Re: Basin Electric Power Cooperative  
Case No. PU-11-696 Antelope Valley Station to Naset 345-kV Transmission Line  
Application Amendment

**Amendment to the Application to the  
North Dakota Public Service  
Commission for a Consolidated  
Certificate of Corridor Compatibility  
and Route Permit**

**Basin Electric Power Cooperative's  
Antelope Valley Station to Naset 345-kV  
Transmission Line  
Williams County, North Dakota**

**Case No. PU-11-696**

# Figure 1.2-1: Overall Proposed Project Area and Proposed Corridor/Route

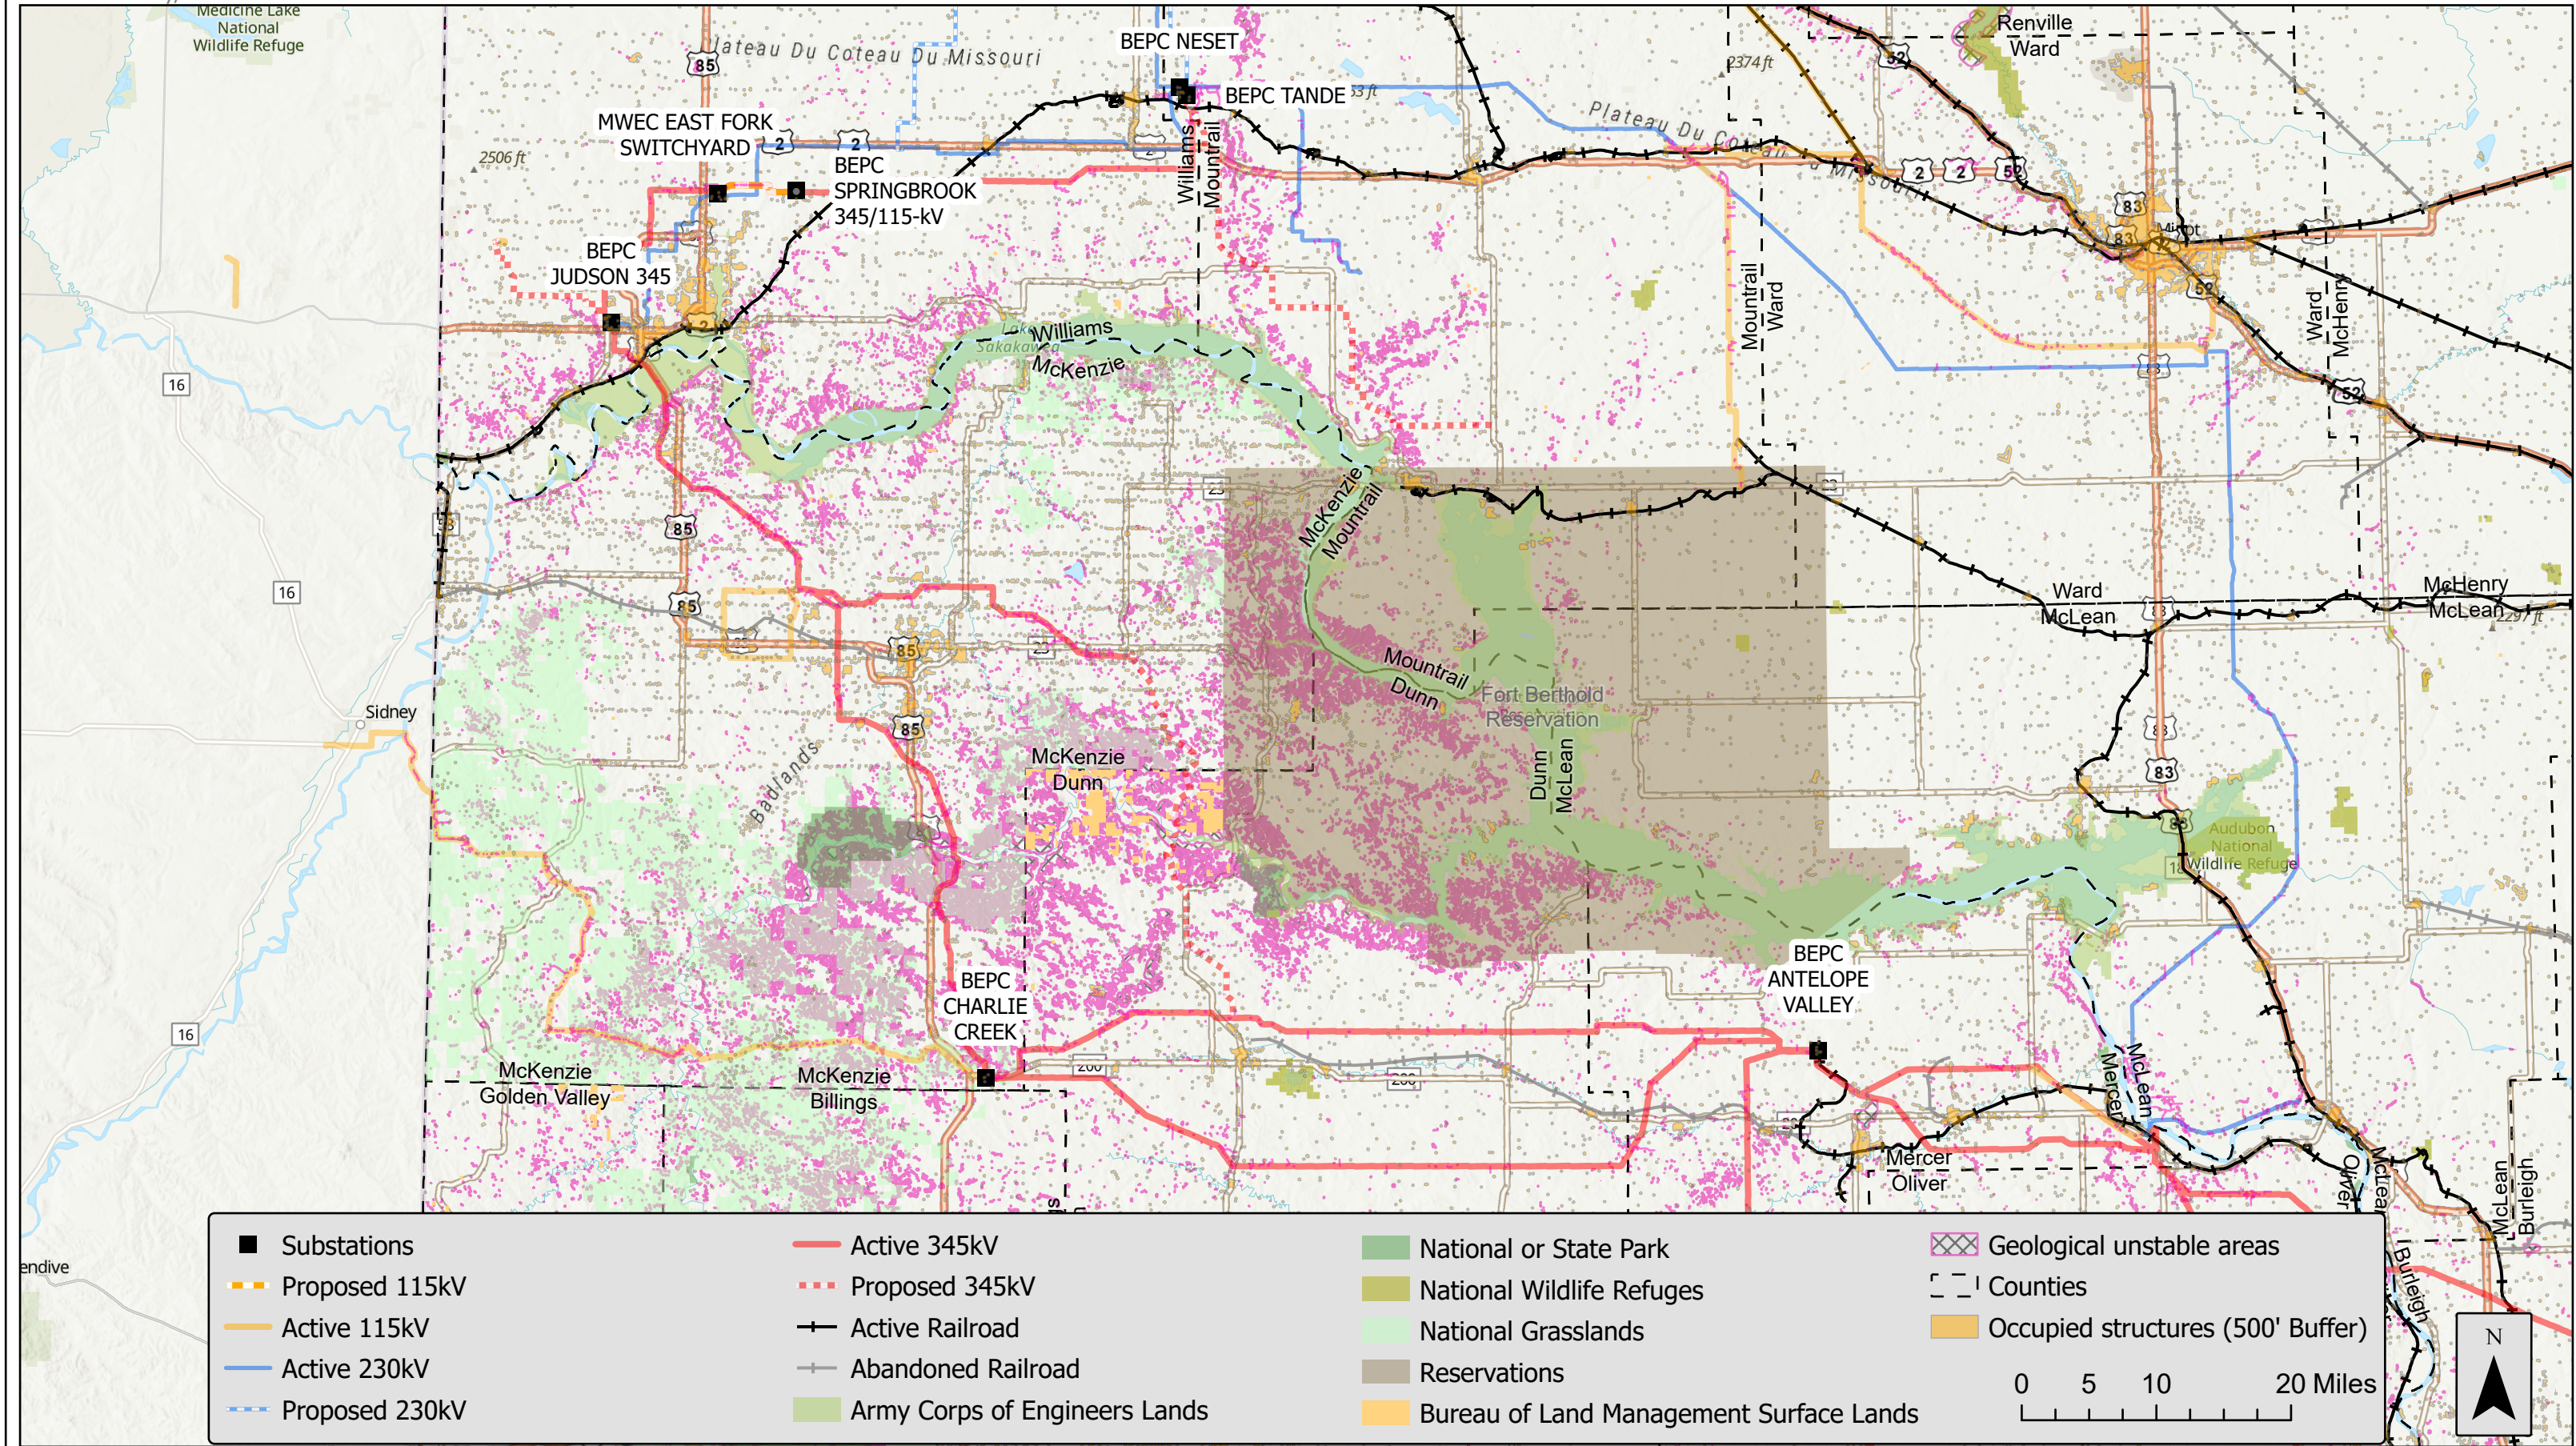
No changes to the original study area or project corridor. The study area for the Project additions was the entire 40.06-acre Basin Electric owned parcel. **Figure 1.2-1** is updated to include the proposed additions.

# Figure 4.2-2: Proposed 345/115-kV Double Circuit Structure Design

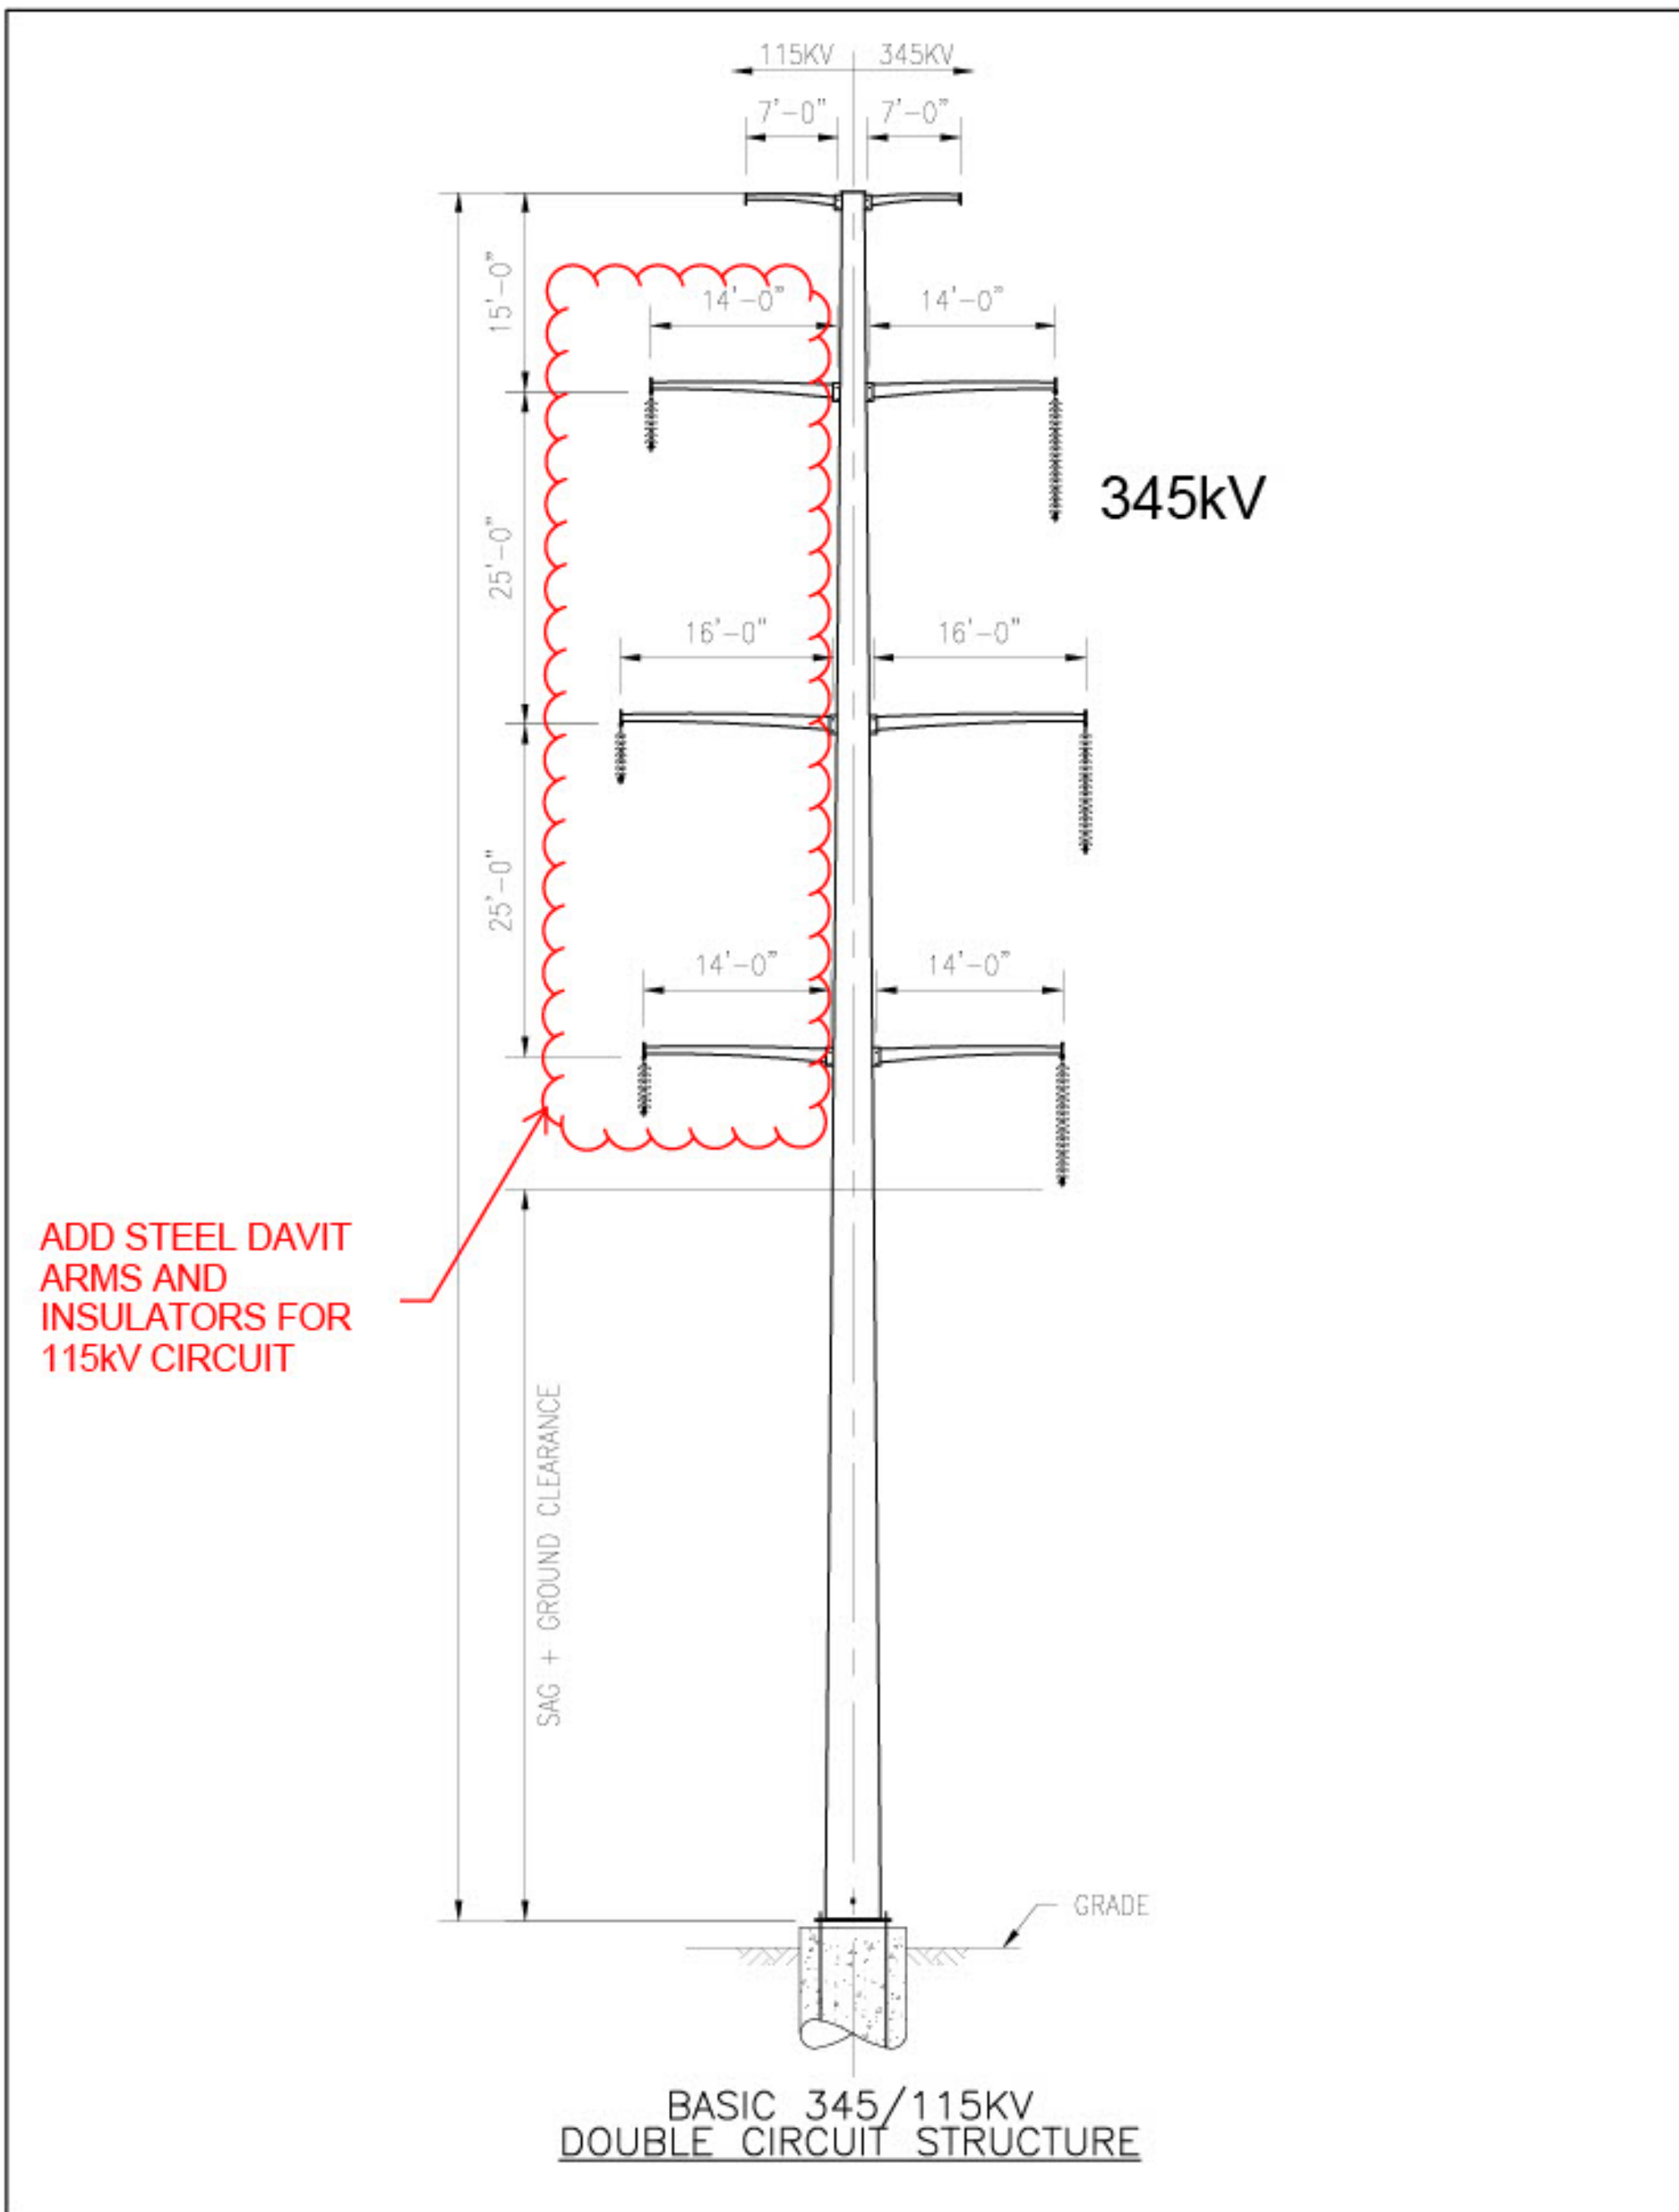
To complete the substation construction, two additional 345-kV structures will be installed to tie the existing AVS to Neseet transmission line into the proposed Springbrook Substation. One structure is located approximately 710' feet outside of the existing corridor on Basin Electric property, and the other is within the existing 345kV corridor with Basin Electric property. The structures will be a single pole, self-supporting on drilled pier concrete foundations. **Figure 4.2-1** shows a typical single pole, self-supporting structure design.

Approximately 6.8 miles of 115-kV transmission circuit will be added to the existing AVS to Neseet 345-kV structures to connect the proposed Springbrook Substation to MWEC's existing East Fork substation. This addition will be accomplished by adding the 115-kV circuit to 37 existing structures. **Figure 4.2-2** shows how the 115-kV transmission circuit will be added to the existing 345-kV structures.
